Wisconsin Department of Transportation

Proposal #18: 1130-64-76, WISC 2024306
Appleton – De Pere
Northland/STH 15 Intchg B440315/16
IH 041
Outagamie County

1130-64-81, WISC 2024229
Appleton – De Pere
Capitol Drive Overpass B440317
IH 041
Outagamie County

This is Addendum No. 03, which provides for the following:

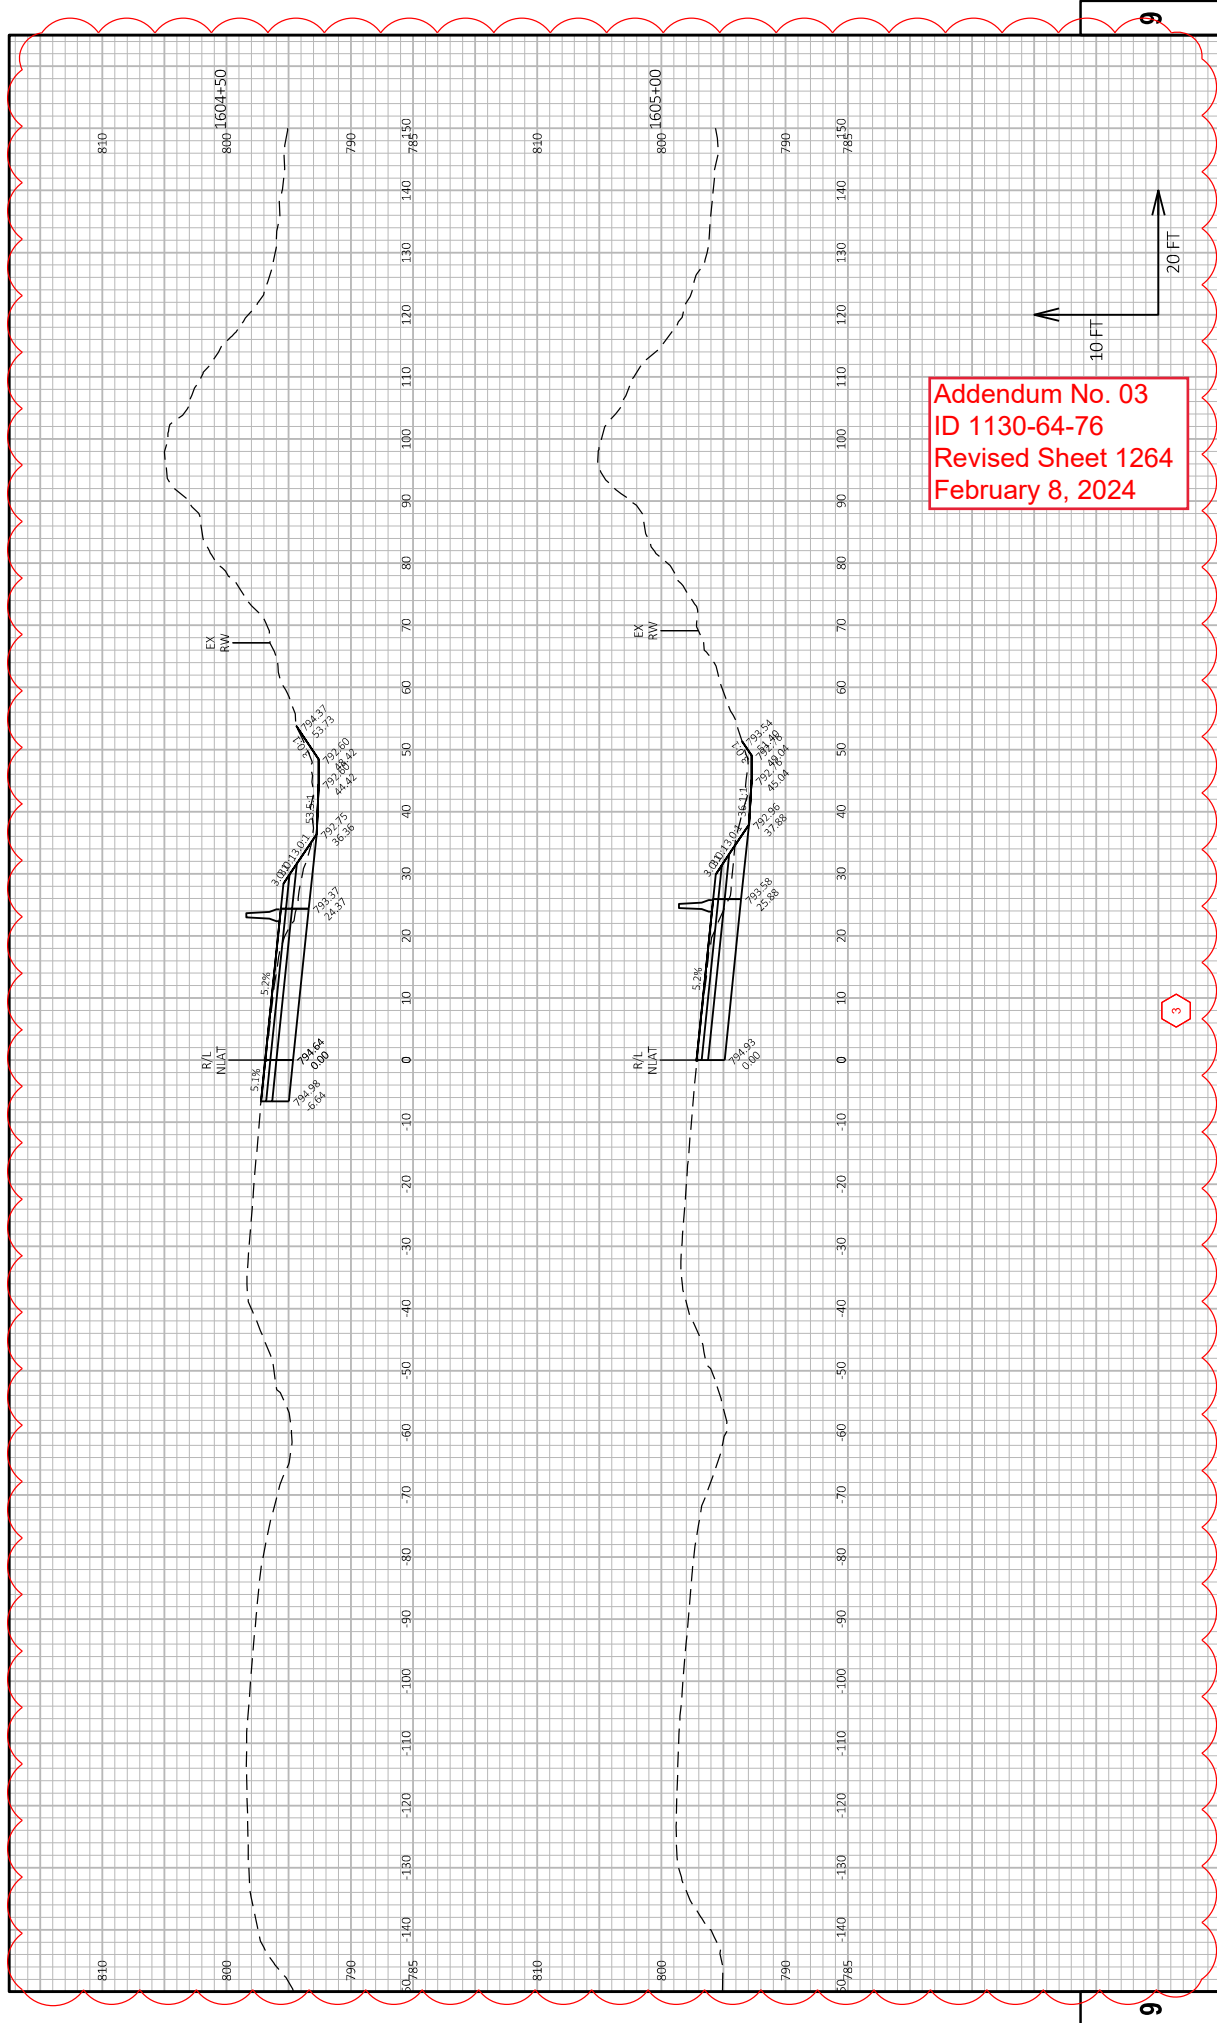
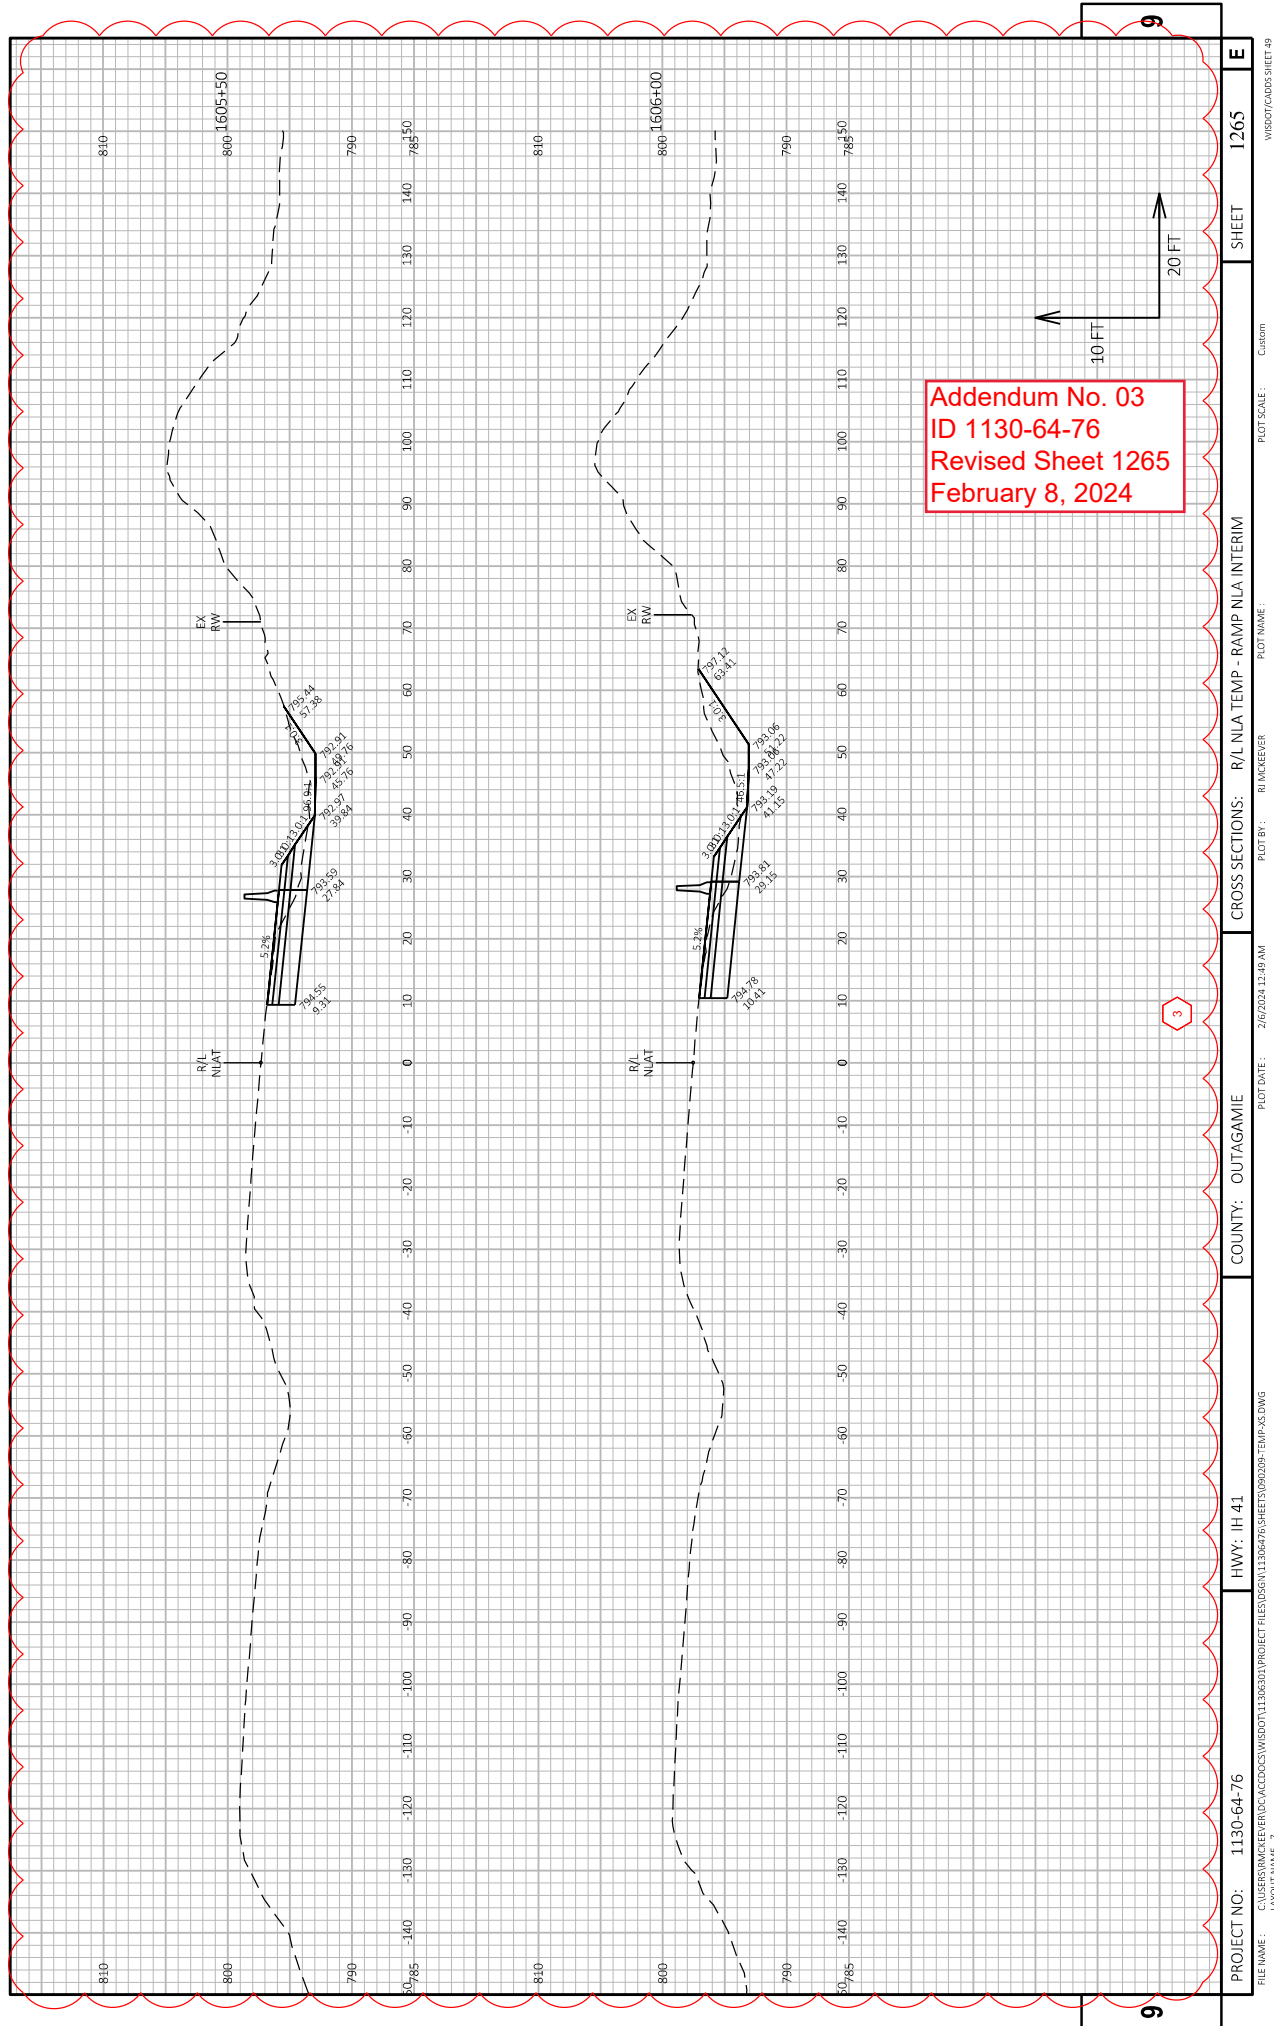
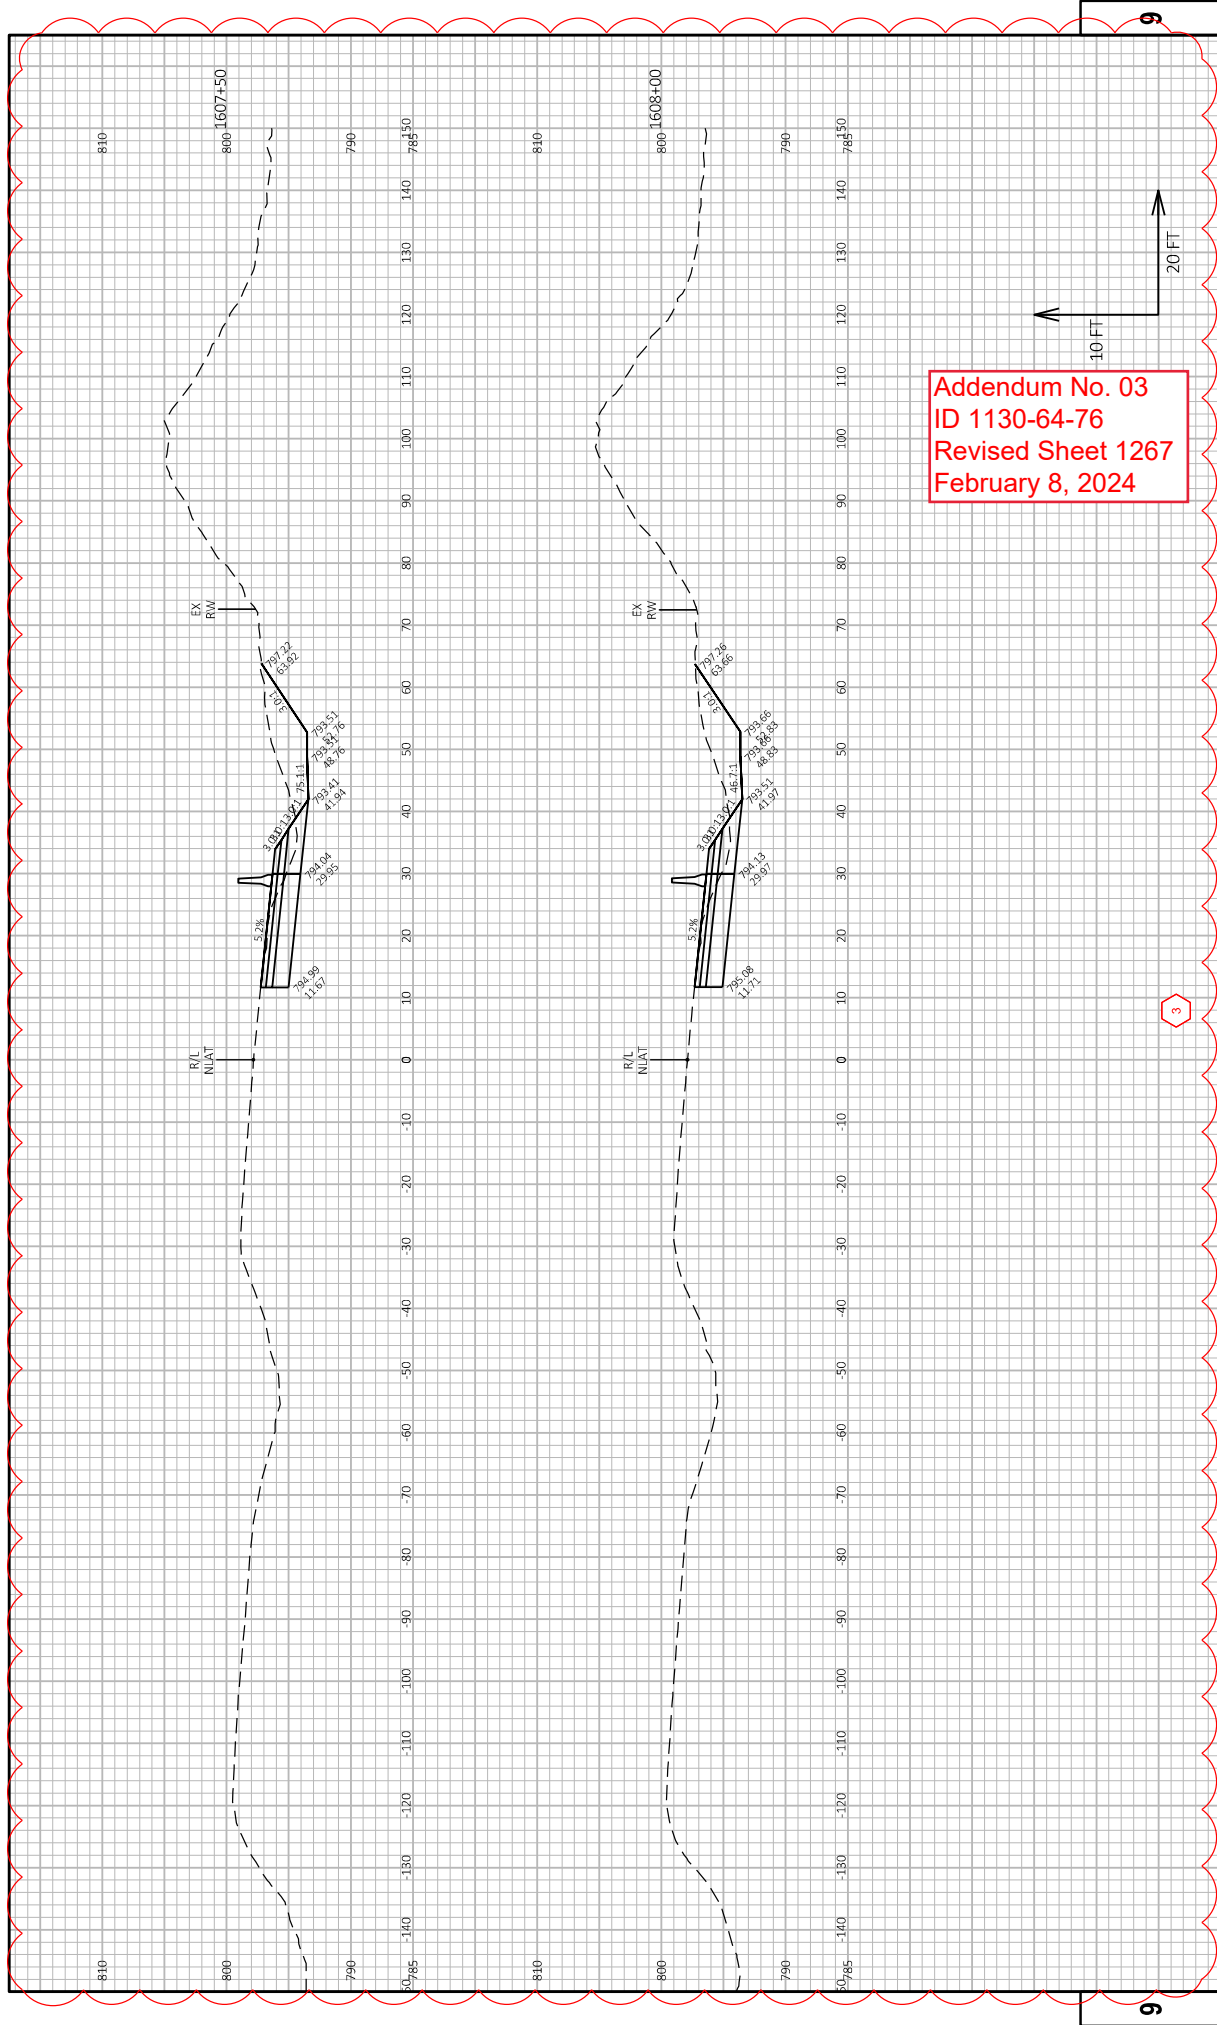
1099	Updated earthwork data for NLAT (Interim Ramp A)
1259 - 1276	Revised NLAT (Interim Ramp A) Cross Sections
